UNITED STATES
NUCLEAR REGULATORY COMMISSION
WASHINGTON, D. C. 20555

October 22, 1985

Docket No. 50-29

LICENSEE: Yankee Atomic Electric Company
FACILITY: Yankee Nuclear Power Station
SUBJECT: MEETING SUMMARY - MEETING WITH YAECo ON ECCS CODE REVISION

YANKEE CORE 17
MULTIPLIER FOR XENON REDISTRIBUTION

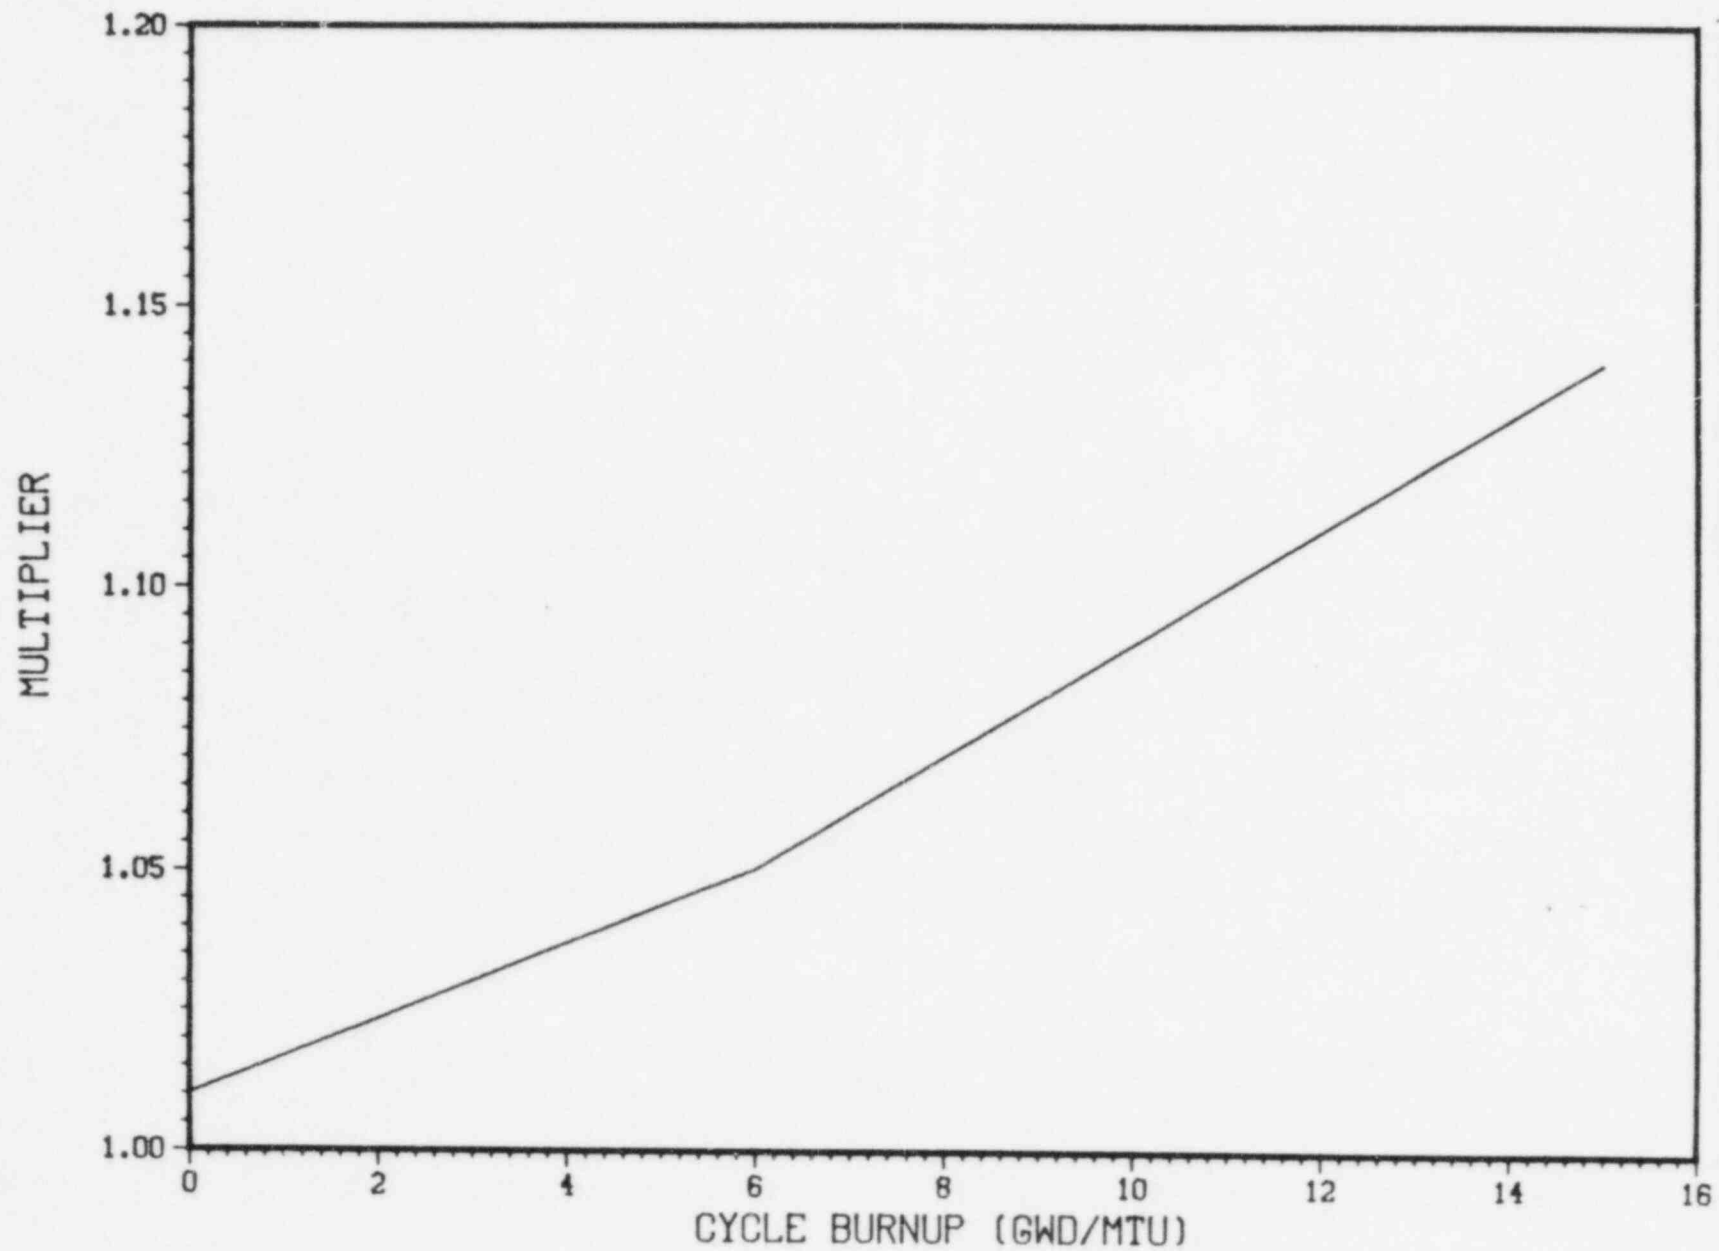
The NRC staff then questioned the licensee regarding plans for removing F_i and F_{xe} from the LHGR calculations. The licensee felt that a bottom shaped flux distribution bounded the cosine curve, and F_i would not be needed in the calculation. In the consideration for F_{xe} , the current TS value for F_{xe} would be modified as a part of the cycle 18 reload submittal, and the licensee is considering other restrictions (e.g., rod motion limits) that may eliminate the need for F_{xe} . As part of the reload submittal, the licensee intends to make a case for eliminating the F_{xe} bottom multiplier (page 26 of Enclosure 3).
